**Subject: DNR Initial Project Review**  
Project I.D. 1021-03-10/80  
STH 93 Bridges B-18-0034, B-18-0119  
Eau Claire County  
T26N, R9W, Section 3

PROJECT NO: 1021-03-80	HWY: STH 93	COUNTY: EAU CLAIRE	PLAN	SHEET	E
------------------------	-------------	--------------------	------	-------	---

STRUCTURE B - 18 - 34

North Abutment

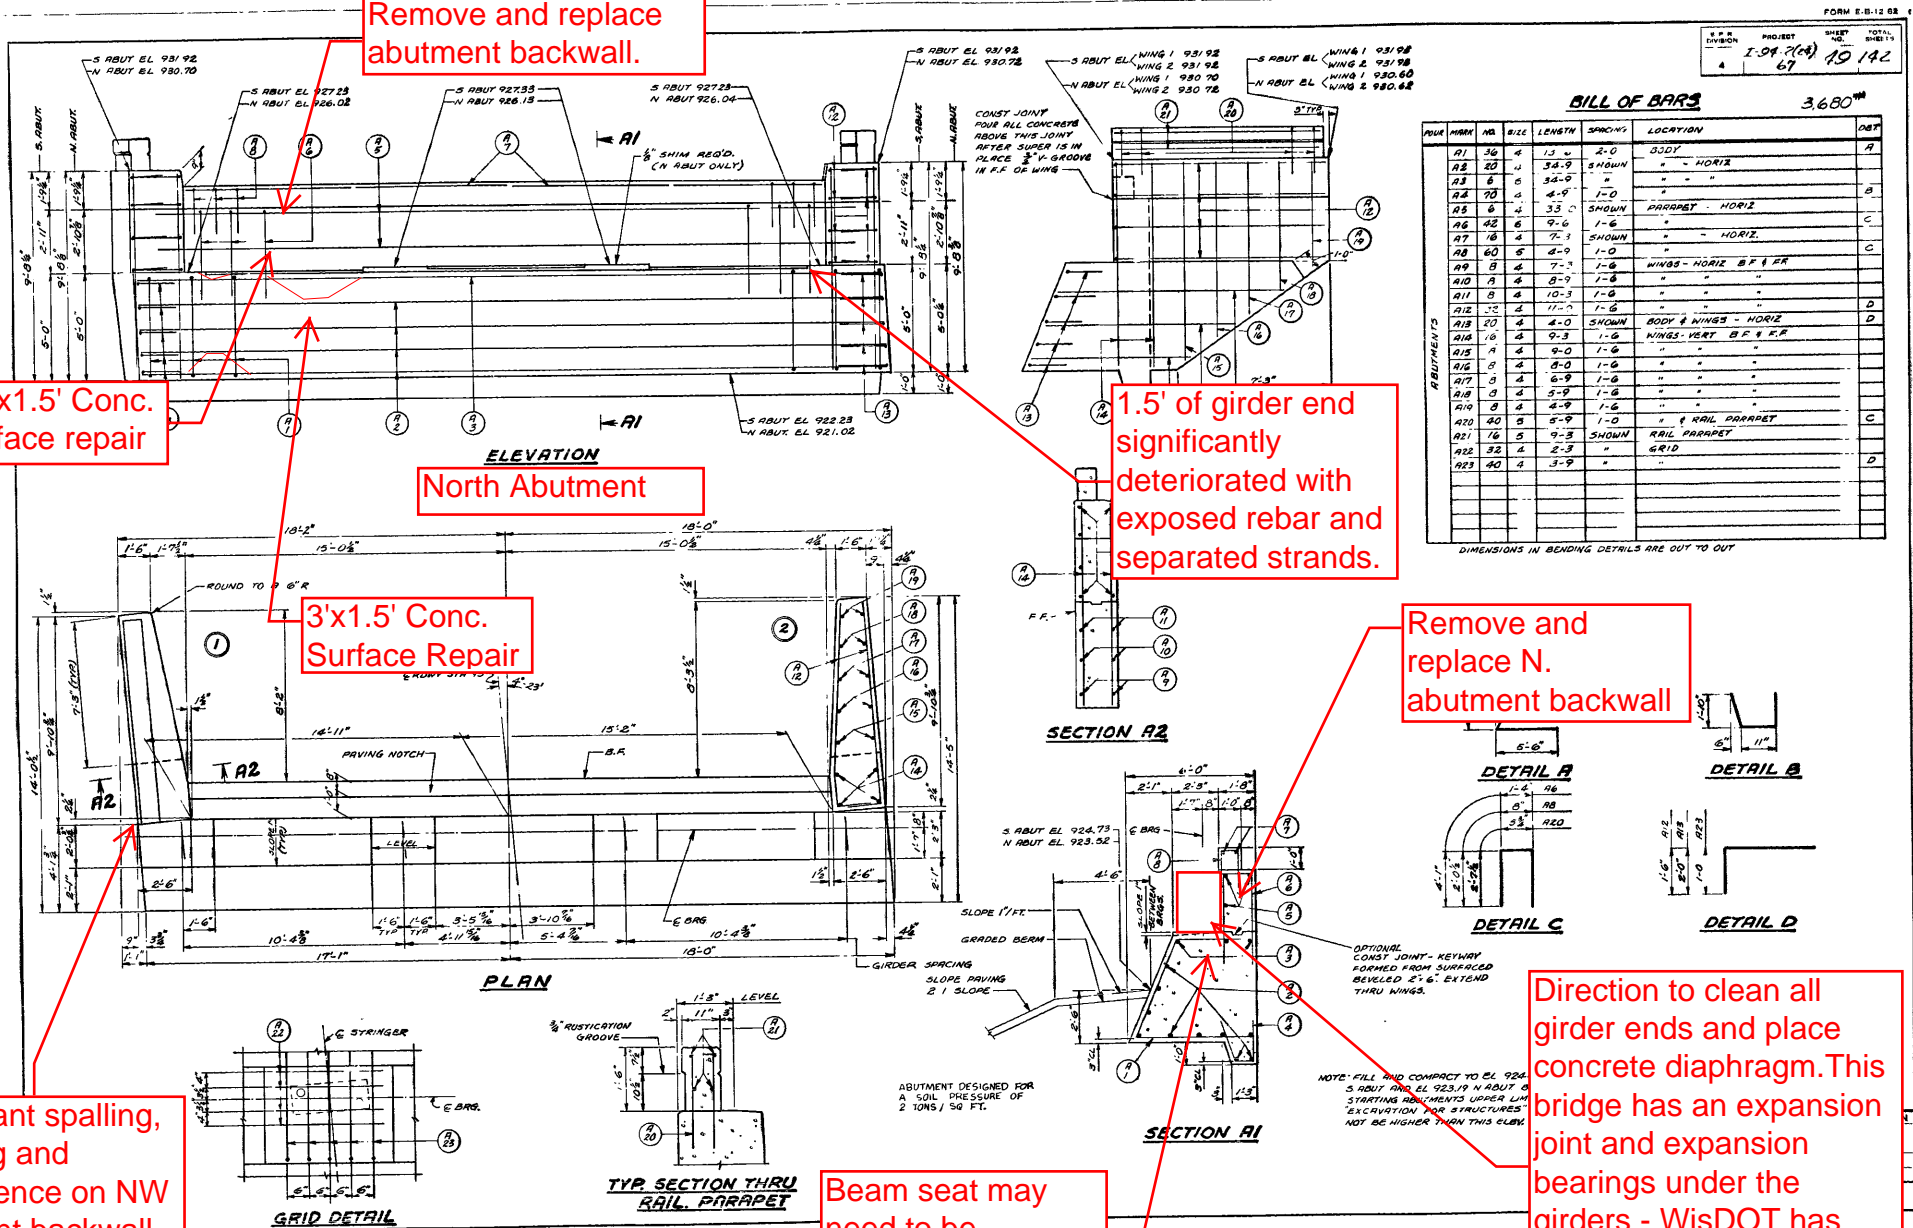
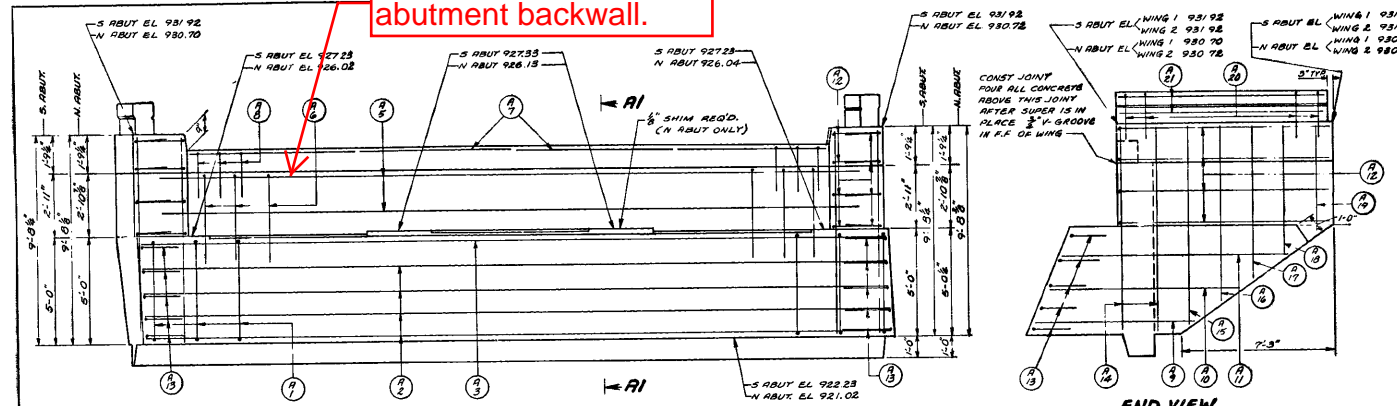
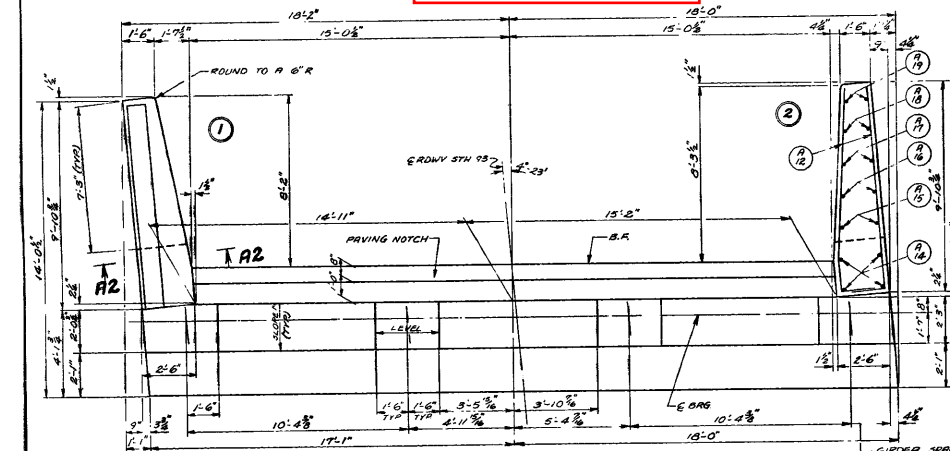
Remove and replace  
abutment backwall.

2.5'x1.5' Conc.  
Surface repair

3'x1.5' Conc.  
Surface Repair

Significant spalling,  
cracking and  
efflorescence on NW  
abutment backwall  
and beam seat.

Beam seat may  
need to be  
removed to a  
certain elevation.

1.5' of girder end  
significantly  
deteriorated with  
exposed rebar and  
separated strands.

Remove and  
replace N.  
abutment backwall

Direction to clean all  
girder ends and place  
concrete diaphragm. This  
bridge has an expansion  
joint and expansion  
bearings under the  
girders - WisDOT has  
directed for a bearing  
conversion to occur.

Remove and replace abutment backwall.

ELEVATION  
LOOKING NORTH

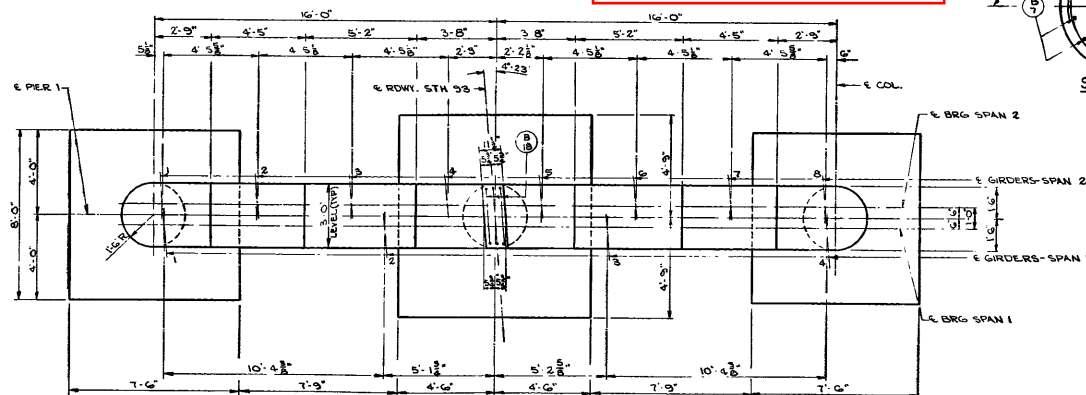
Fiber wrap all 3 piers

PIER 3

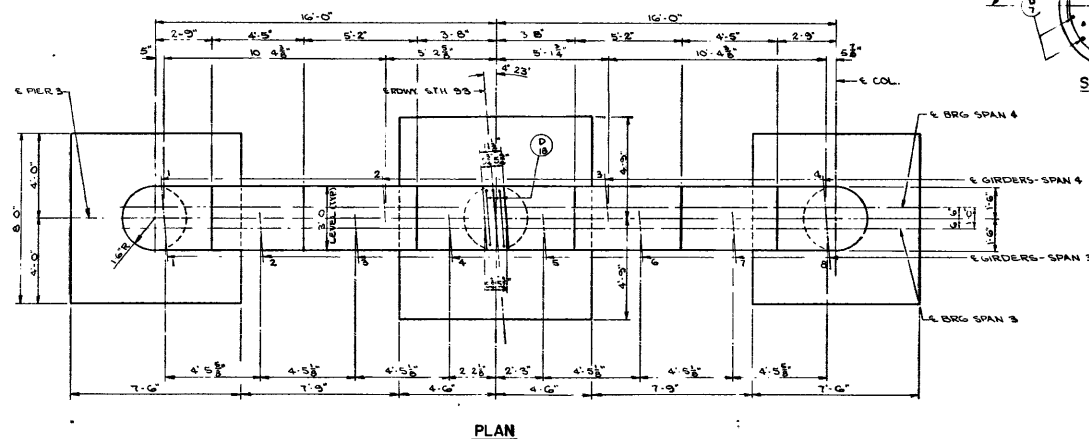
Fiber wrap all 3 piers
